## NHTSA SAFETY RECALL

### **Safety Recall Notice Campaign #06V-301 Ignition Module Relocation Remedy**

## 2005 BULLDOG and 2005-2006 N-CHOPPER/MASTIFF IGNITION MODULE RELOCATION Recall #06V-301

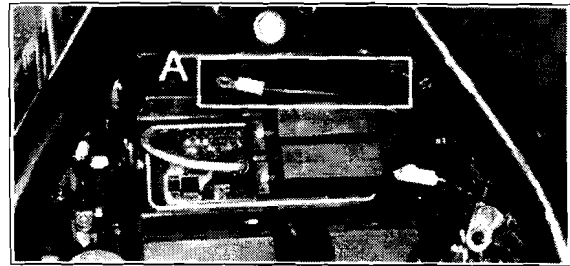
The purpose of this recall is to correct vibration issues with the ignition module mounting system of the listed models. Install Ignition Module Relocation Kit P/N 203-000015-00.

A. Route ignition module wire here.

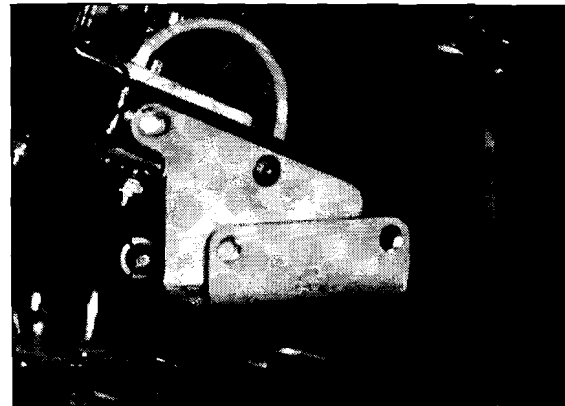
6. Remove the black wire from the circuit breaker and route in front of the EHC.

**NOTE:** Lift the EHC out of the way to install the ignition module mount.

Typical. Note lock nut position.

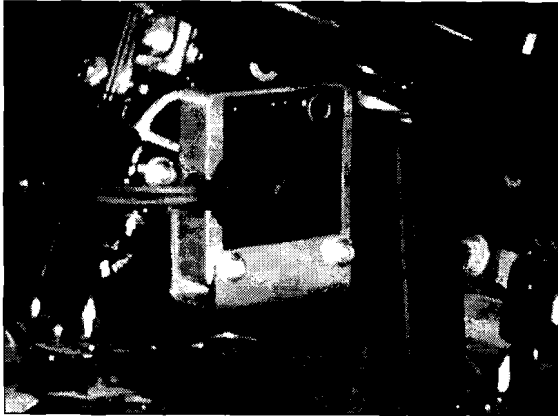
7. Install the ignition module relocation mount using the #10-24 screws and lock nuts provided. Install the front screw with the head facing the EHC, while the rear screw will be installed with the lock nut facing the EHC.

*Typical.*

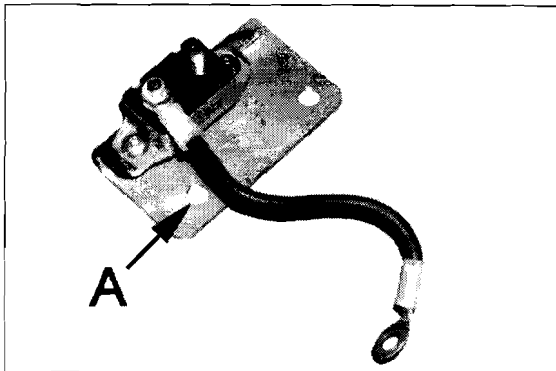
8. Install the ignition module in the mount using the original hardware. Use Loctite 2440 on screw threads. Make sure there is adequate clearance between the oil tank fill neck and the ignition module.

9. Install and tighten the EHC.

**IMPORTANT:** Over torque on the EHC nylon nuts or connector screws may damage the EHC. **Do not** tighten nylon nuts more than 15 in•lbs.

*A. Outer mounting hole.*

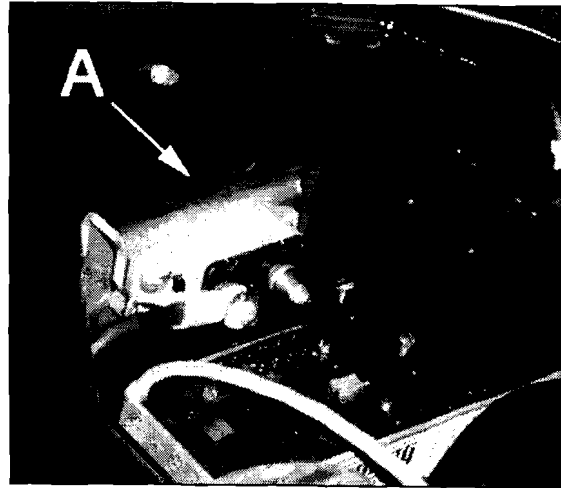
10. Install the circuit breaker on the relocation mount using the previously removed hardware.
11. Loosely install circuit breaker and mount where ignition module was previously located. Install the 1/4-20 x 3/4" screw, washer, and lock nut in the **outer mounting hole only**.

*A. Front battery tray mount.  
B. Grommet.  
C. Bushing.*

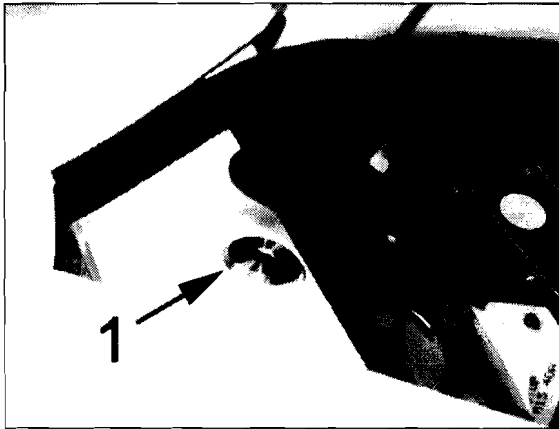
12. Loosen the rear battery tray mounting bolts. Remove and discard the front battery tray mounting bolt and the well nut. These will not be reused.
13. Install the grommet and bushing into the new front battery tray mount.

1. Front battery tray mount.

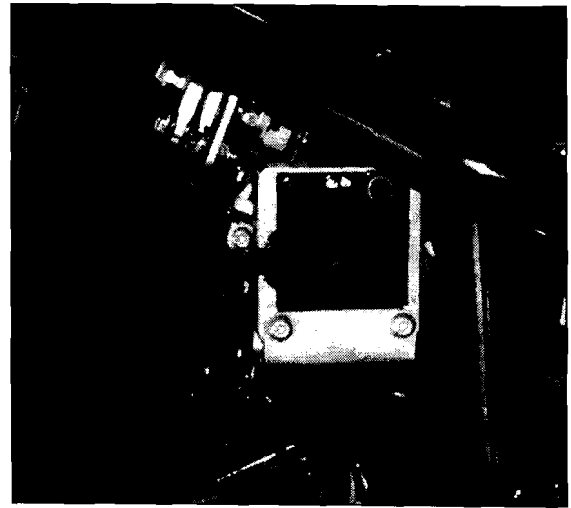
14. Apply Loctite 2760 to the threads of the tray mounting screw (P/N 240-000218-00) and install by placing the screw into the old well nut opening under the front of the battery tray as shown in the next image.

**NOTE:** Before fully tightening the tray mounting screw, install the 1/4-20 x 1-1/4" hex screw and fender washer through the front of the battery tray mount as shown in the next image.
